**File: OZ-8286
Planner: N. Musicco**

TO:	CHAIR AND MEMBERS PLANNING & ENVIRONMENT COMMITTEE
FROM:	JOHN M. FLEMING MANAGING DIRECTOR, PLANNING AND CITY PLANNER
SUBJECT:	APPLICATION BY: MHBC PLANNING URBAN DESIGN AND LANDSCAPE ARCHITECTURE 545 FANSHAWE PARK ROAD WEST PUBLIC PARTICIPATION MEETING ON: MARCH 25, 2014

Conceptual Site Plan

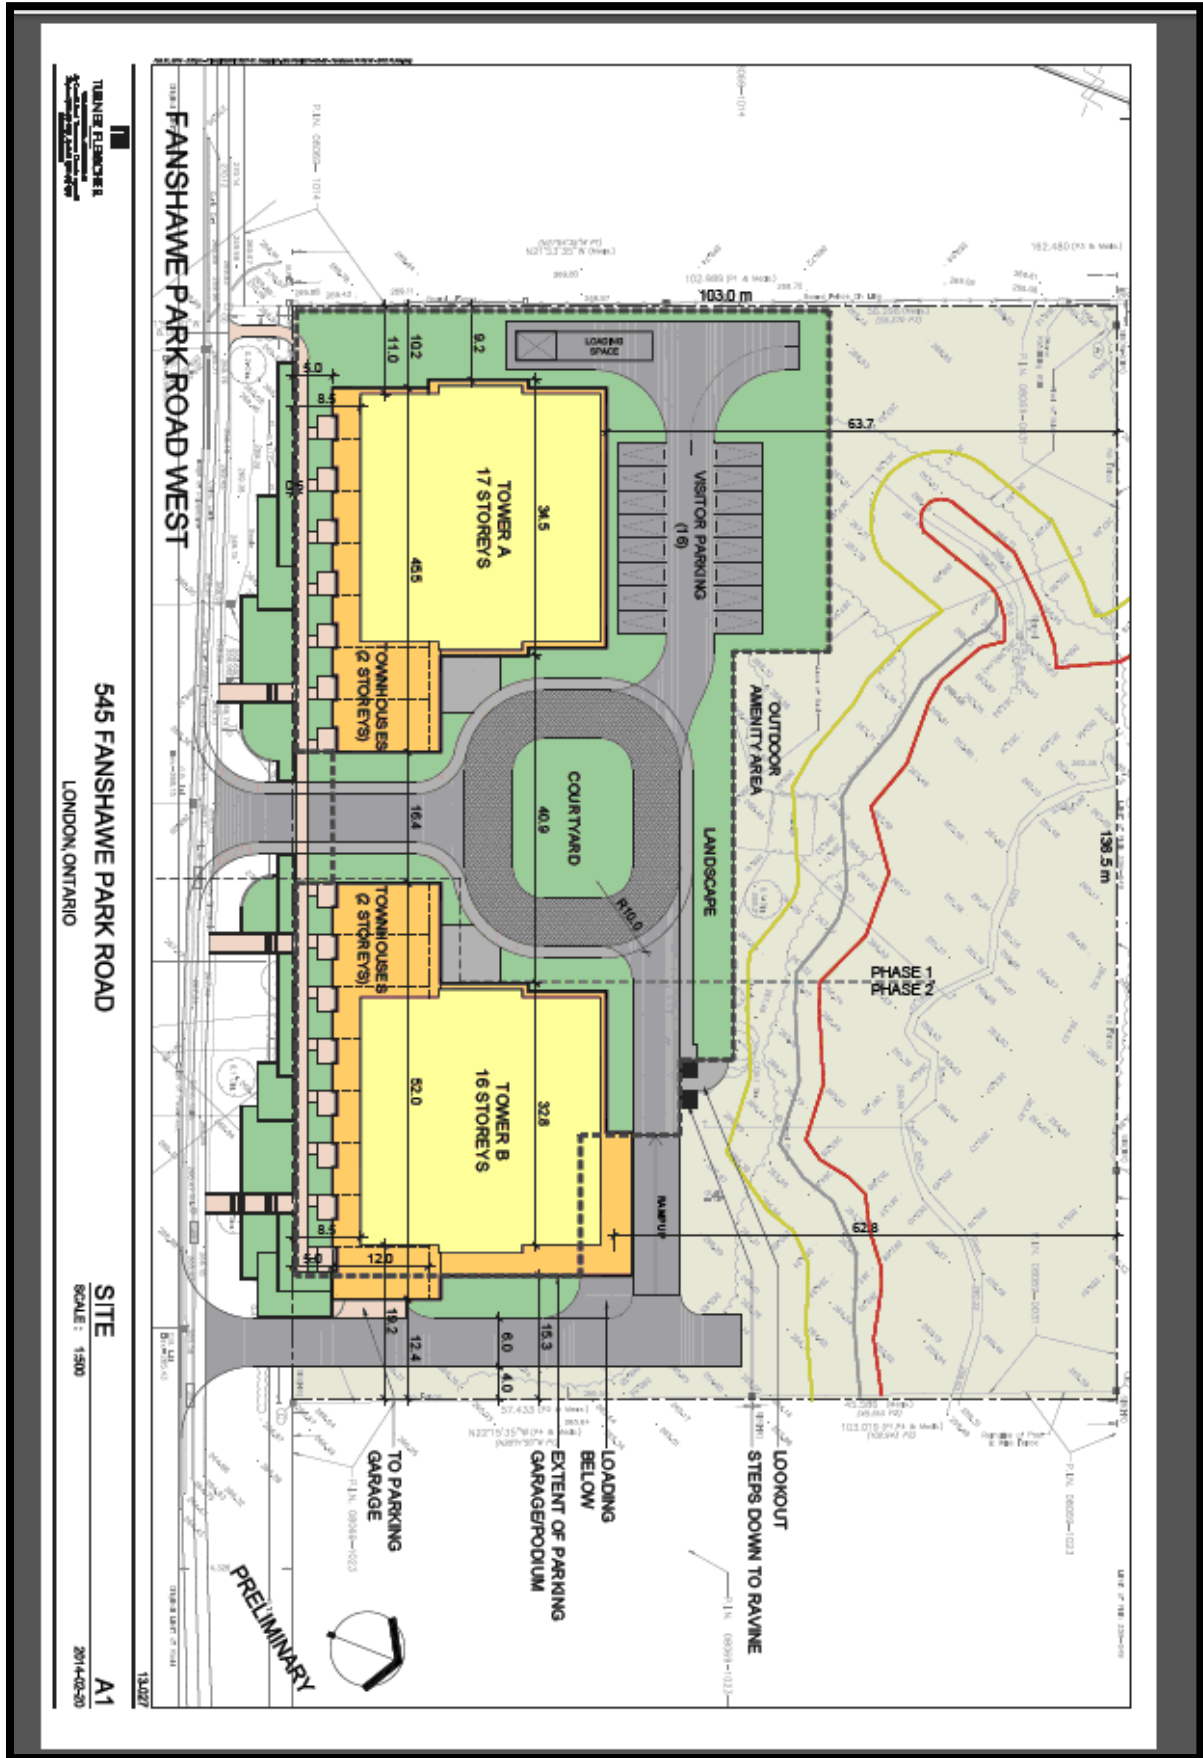
- Develop the edge treatment by enlarging the terraced gardens along the entire Fanshawe Park frontage incorporating the proposed staircases as shown on the existing plan in order to create an urban edge condition between the building face and public sidewalk.

- Consider a courtyard space at the central drive by eliminating the centre lane and incorporating a water feature or public art, along with a high level of planting to improve the public realm.

- Ensure a high level of planting between the public sidewalk and the parallel pathway at the podium. Consider planters that are not as symmetrical in response to the topography to strengthen the landscaped open space.

- Consider adding another pedestrian connection, or shifting the proposed connection to the public sidewalk at the southwest corner of the site, to relate more to the likely pedestrian activity to the adjacent commercial development.

The close proximity of this subject site in relation to a major intersection such as the intersection of Fanshawe Park Rd and Wonderland Rd makes access problematic. This intersection accommodates significant volume of traffic on a continual basis. As traffic volume grows due to development in the north part of the city and other parts, it is anticipated that Fanshawe Park Rd and Wonderland Rd will be widened to 6 lanes within the next 20 years as recommended in the recently Council approved Transportation Master Plan. Dual westbound left turn lanes were constructed at this intersection to accommodate existing and future traffic volume and include a centre median island for safety and operation of the dual left turn lanes. The island extends approximately across half the frontage of this site and will block the proposed centre access shown on the concept plan.

9. *On Figure 8 Development Proposal Overlay, it appears that a portion of the parking garage/podium is encroaching into the erosion hazard limit which is not consistent with UTRCA policy. Development is not permitted in the erosion hazard limit and as such the foot print of the garage should be revised accordingly.*

Schedule '1'

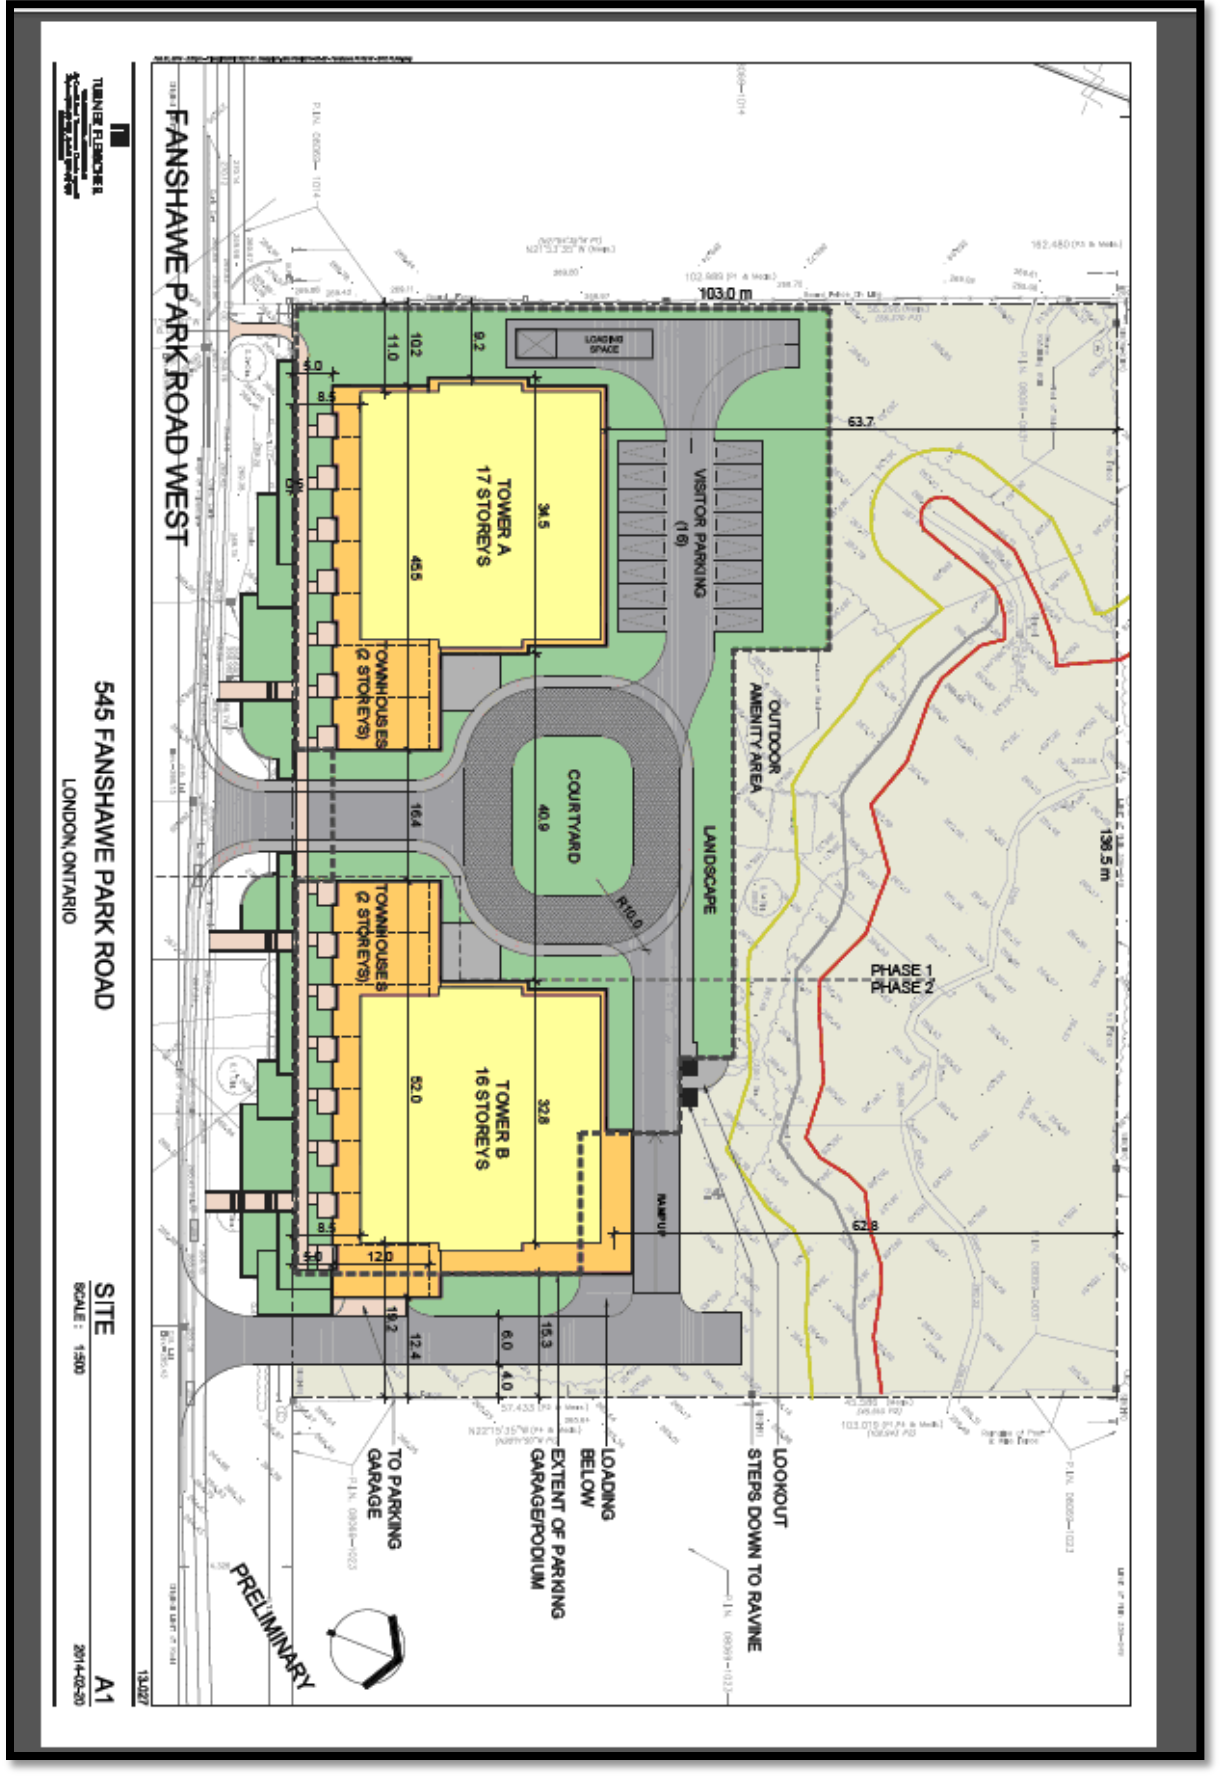
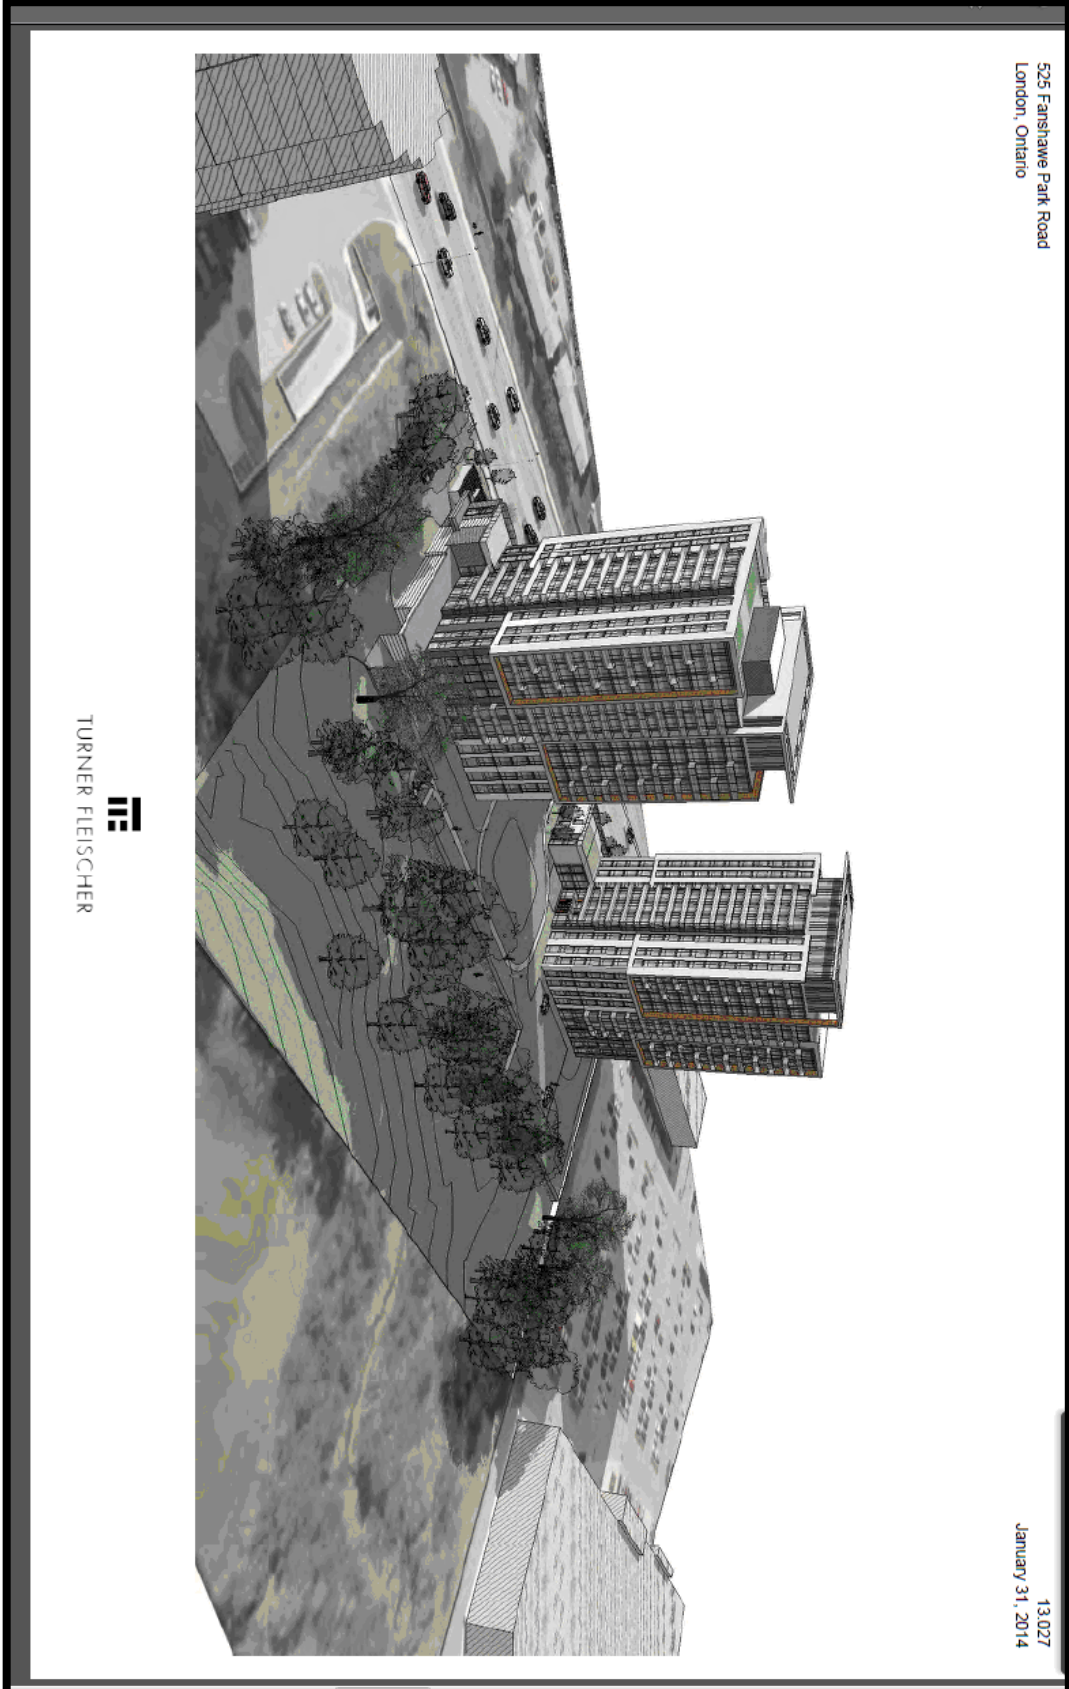
- Include options such as fencing, landscaping and the location of parking for the edge treatment which abuts the Open Space in order to create a positive relationship between this site and the Open Space.

- Encourage the use of the sloping topography as an opportunity to develop a natural podium and consider multiple steps and the possibility of sunken courtyards for the townhomes and creating a positive interface of the site with the ravine to benefit from the natural topography

- Consider façade enhancements and fenestration for the townhome at the south-east corner to articulate the east elevation.
- Consider high quality building materials that are consistent with the high quality of the design to enhance the building design and ensure its long term durability.

- Consider the provision of a green roof to enhance the amenity space at the podium roof and to reduce the heat island effect on this site.
- To improve the storm water management generated from this development, consider using permeable paving materials wherever possible and cost-effective.
